### ADDENDUM

| Project: LORIN FARR 2, 4, 6 PAVILION | Project No.: <u>503-3195</u> | Addendum No.: 2 |

Date: 05/16/2024

Project Address: 770 15<sup>TH</sup> STREET, OGDEN, UT 84404

## **GRADING AND** DRAINAGE PLAN

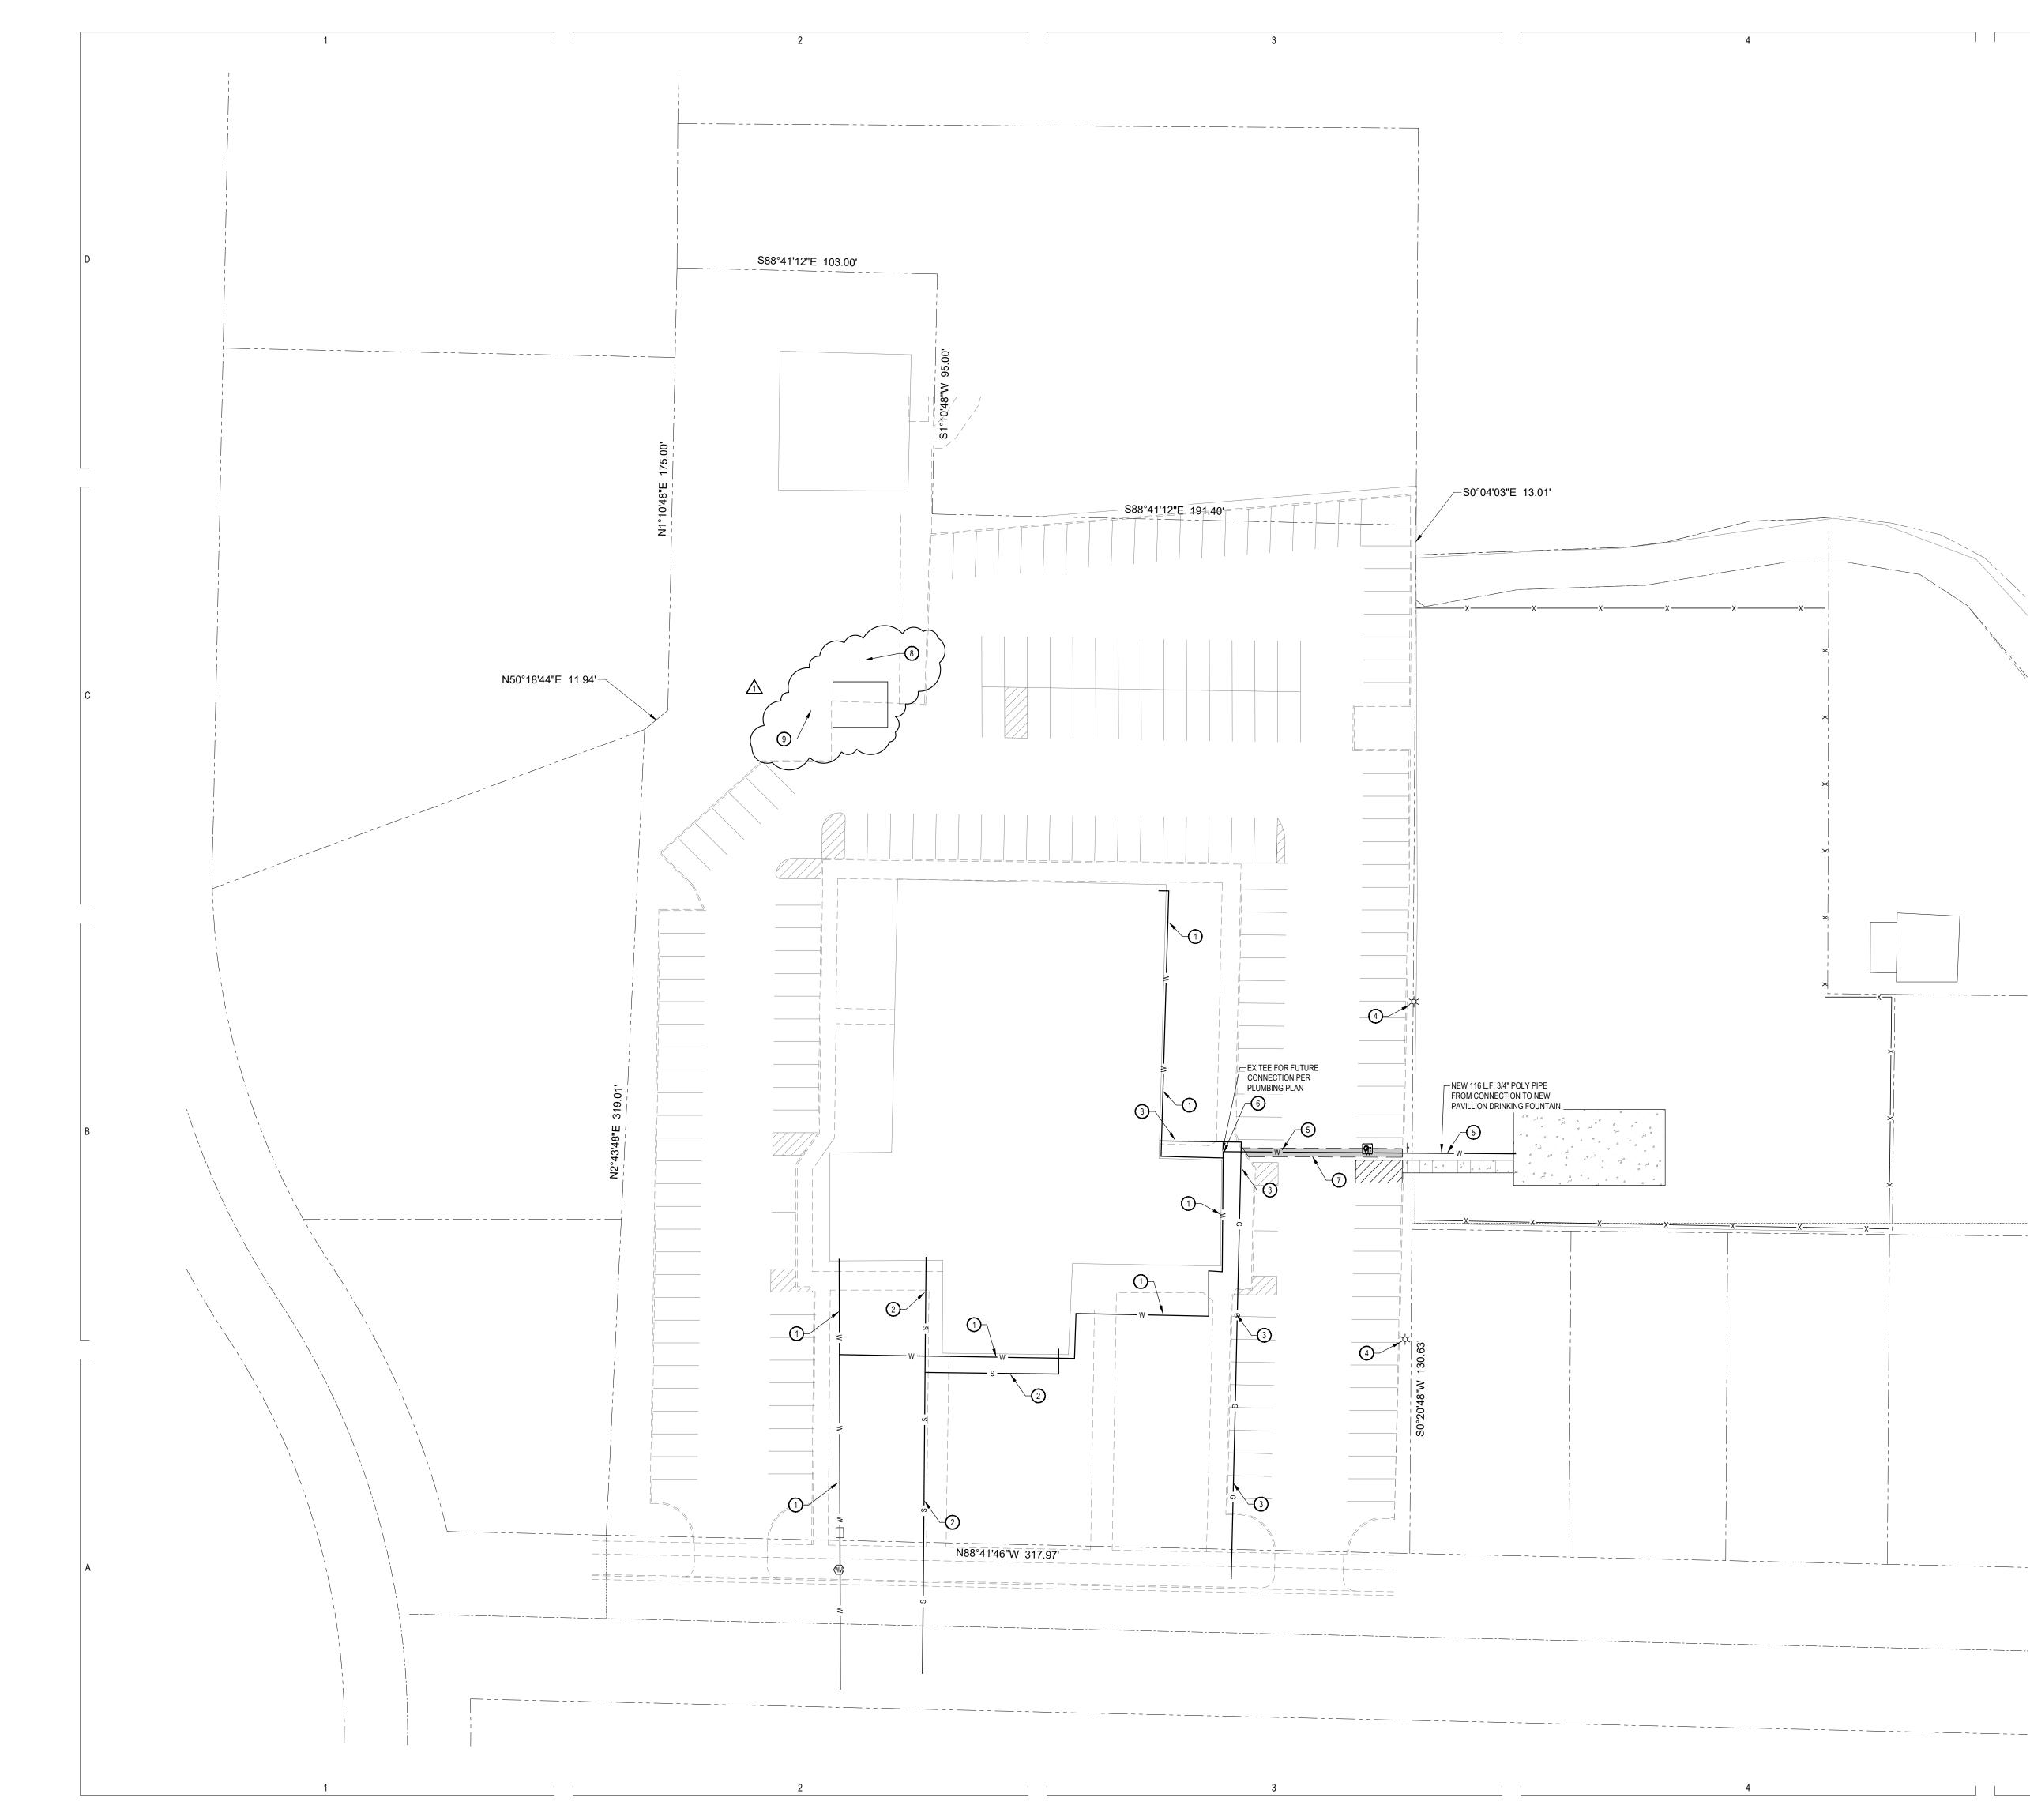
- a. Exterior materila legend has been updated, see A110.1
- b. Electrical lighting specs has been updated, see E110.1
- c. Electrical power plan has been updated, see E110.1
- d. General notes has been added to the sheet A500
- e. T-patch details has been added to the sheet C4.01
- f. Civil site plan has been updated. See C1.01
- g. Landscape irrigation plan has been updated. See L122
